Re: Application for Approval of the Long Lake South Project

LONG LAKE SOUTH PROJECT

Environmental
Impact Assessment (EIA)

Additional Supplemental Information

Figure 7-1 Fresh Water Demand Long Lake and LLS

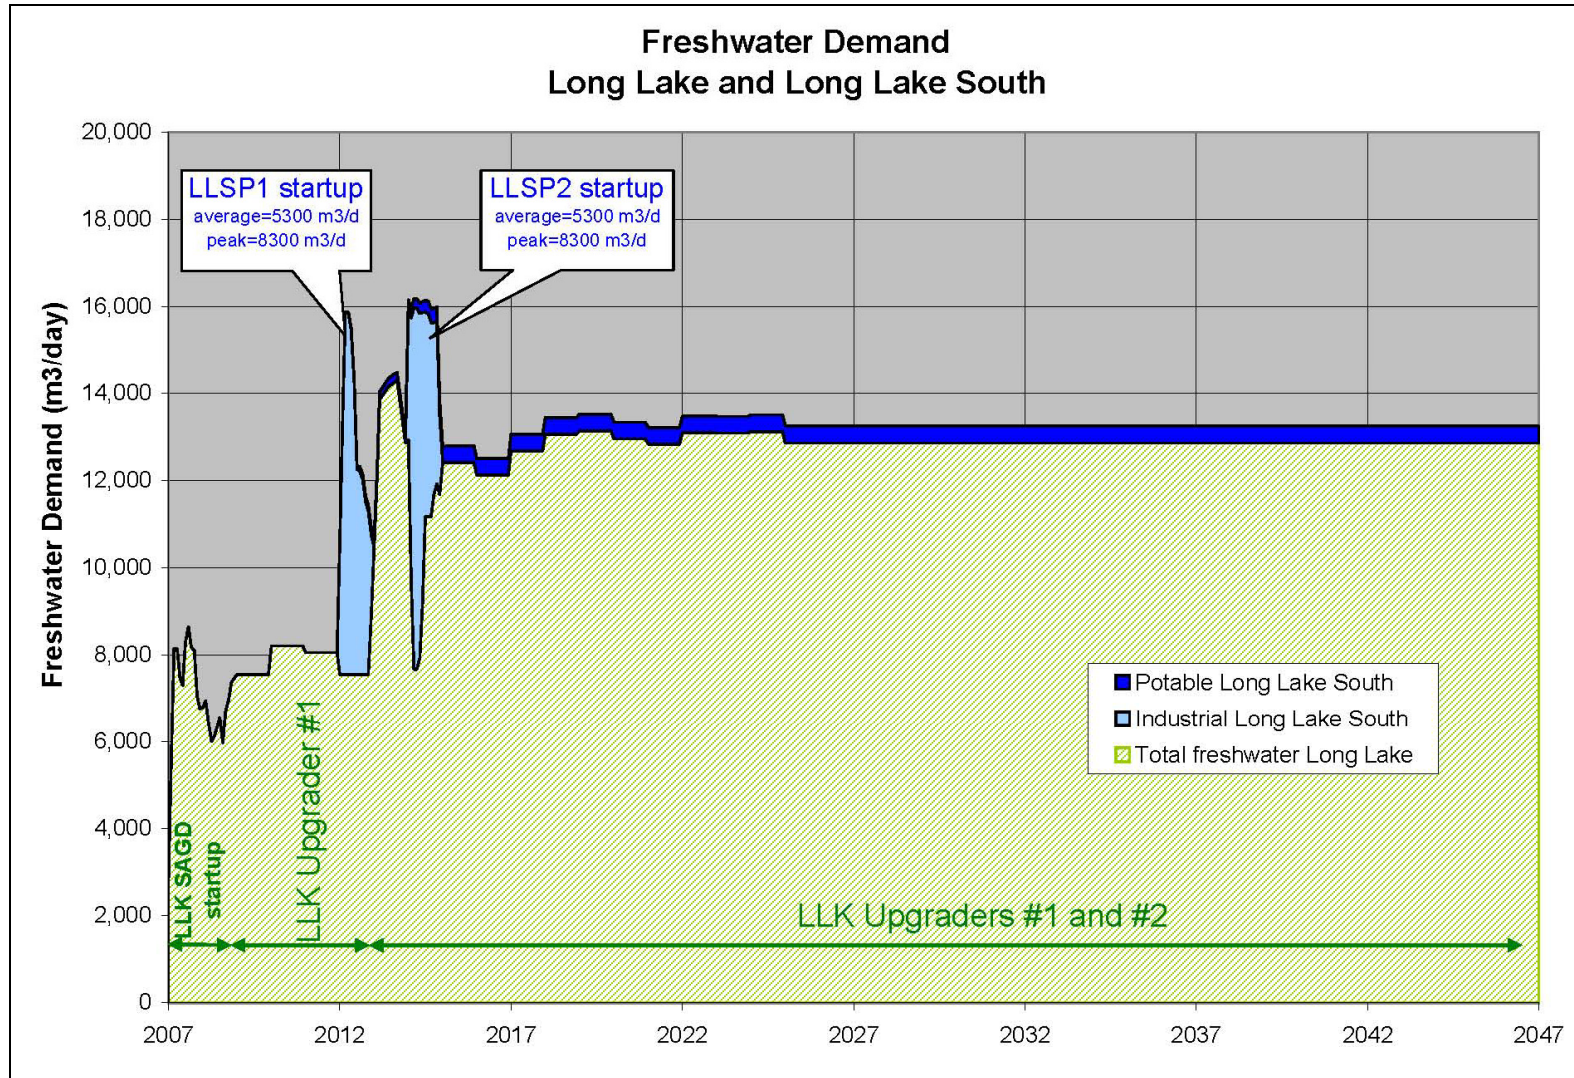
7.	<p>Supplemental Information, Part 2, Section 1.5 Water Use, SIR Response #20, Page 16</p> <p>A <i>Water Act</i> Application (File No. 00237030) was made to Alberta Environment (AENV) under Sections 37(1) and 50(1) of the <i>Water Act</i> (WA) for the diversion and use of groundwater and plant site surface water management. The diversion and use of non-saline groundwater includes 140,890 cubic metres of groundwater per annum for the administration buildings.</p> <p>Table 20-1 (Supplemental Information, Part 2, Following Page 16) presents an overall water balance forecast for the Long Lake Lease. A peak freshwater demand of 26,347 m³/cd is identified for Month 31 with a steady state requirement of 13,244 m³/cd in Year 2025.</p> <ol style="list-style-type: none"> Table 3.2-1 (Page 130) in Volume 1 of the Application gave the expected case and high case fresh water demand as 10,275 m³/d and 14,299 m³/d, respectively. This information was superseded in the Supplemental Information. Explain why the updated steady state and peak water demands shown in Table 20-1 (and noted above) are so much higher than the initial values from the Application. Provide details on where the additional freshwater supply will be obtained, and evidence that the source will meet demand; and Provide a table showing the quantity of freshwater that is being allocated to the various components of Long Lake Project (i.e. Long Lake SAGD, Upgrader and LLS SAGD) over the life of the project (include all phases).

As shown in Figure 7-1, an average of 5,300 m³/d of fresh water is required for 12 months during start-up of LLS Phase 1 and LLS Phase 2 (peak of 8,300 m³/d), while the overall fresh water for the combined LLS and Long Lake Projects is approximately 14,000 m³/d at steady-state. As illustrated in Figure 7-1, the fresh water required for the LLS start-up is equivalent to extending the fresh water requirements for Long Lake by one year (41 years instead of 40 years). The cumulative impacts due to the LLS and Long Lake projects will be nearly identical in magnitude and in duration to the impacts due to the Long Lake Project. The cumulative impacts due to the Long Lake Project have already been studied in the 2003 Long Lake EIA for a total fresh water demand of 9,000 m³/d. The cumulative impacts due to the Long Lake Project for the increased fresh water demand (total of approximately 14,000 m³/d) will be presented under separate cover in a project update for the Long Lake Project. This Long Lake Project update will also discuss monitoring and possible mitigation measures if required.

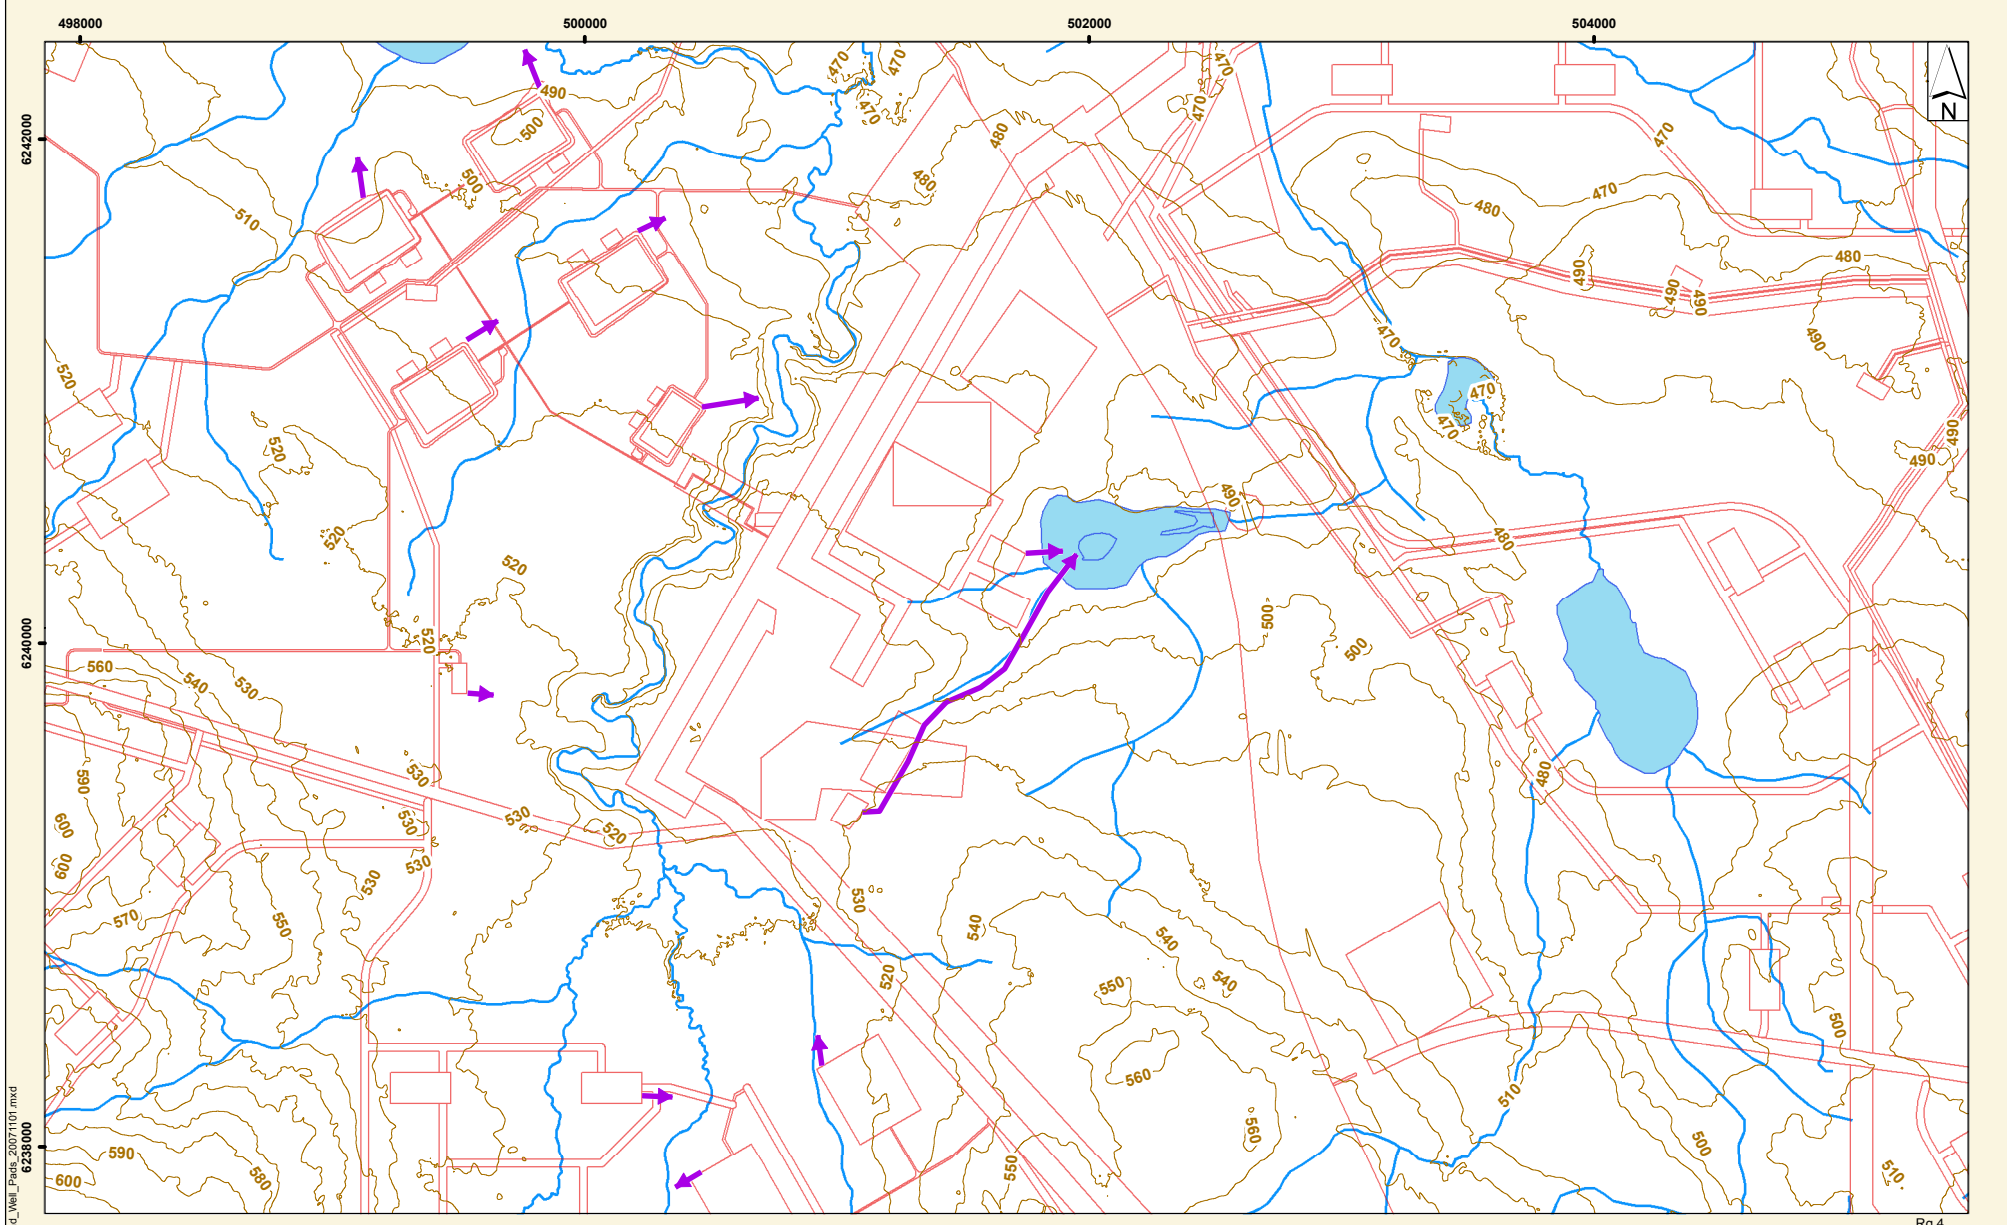
12.	<p>Supplemental Information, Part 2, Section 2.6 Water Supply & Management, SIR Response #111, Page 137</p> <p>a) Figure 111-1 does not provide all discharge points for well pad run-off containment units or facility run-off ponds. Provide this information, including topographical map with surface features.</p>
-----	---

The discharge points and drainage patterns from the Project's initial 5 well pads are presented in Figure 12-1. Other pads presented on Figure 12-1 are conceptual at this time; therefore, discharge points will be established in the future prior to construction.

The surface water features associated with the Project and specific release points are presented in Figure 12-1. The majority of watercourses and waterbodies in the Project area are not officially named. For the purpose of the Project's aquatic assessments, each watercourse and waterbody was assigned a specific designation (i.e. Waterbody 18 (WB-18)).
